Submission of Further Information (FI)

**Proposed Temporary Government Use (Maintenance Depot) for a Period of 10 Years
in “Residential (Group D)” Zone,
Government Land in D.D. 103, Au Tau, Yuen Long
(Application No. A/YL-KTN/1265)**

Further Information for Planning Application No. A/YL-KTN/1265**Response-to-Comments****Comments from Electrical and Mechanical Services Department**

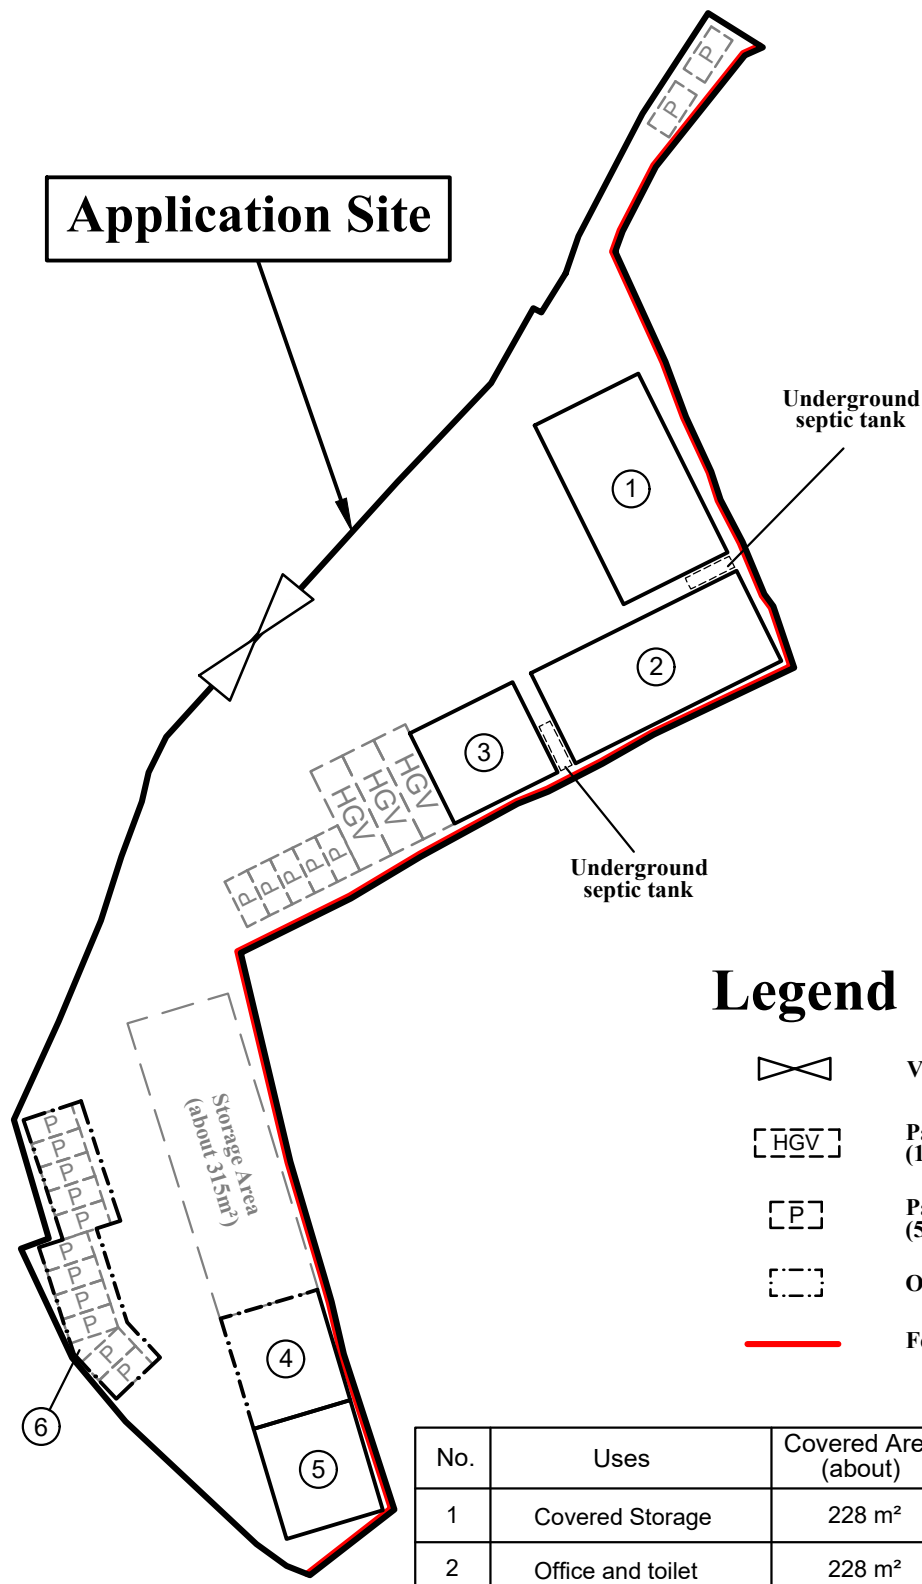
6.	Please indicate the location of the septic tank and soakway system on the layout plan;	Please refer to the updated layout plan (Plan 3a) for the proposed location of the septic tank and soakway system.
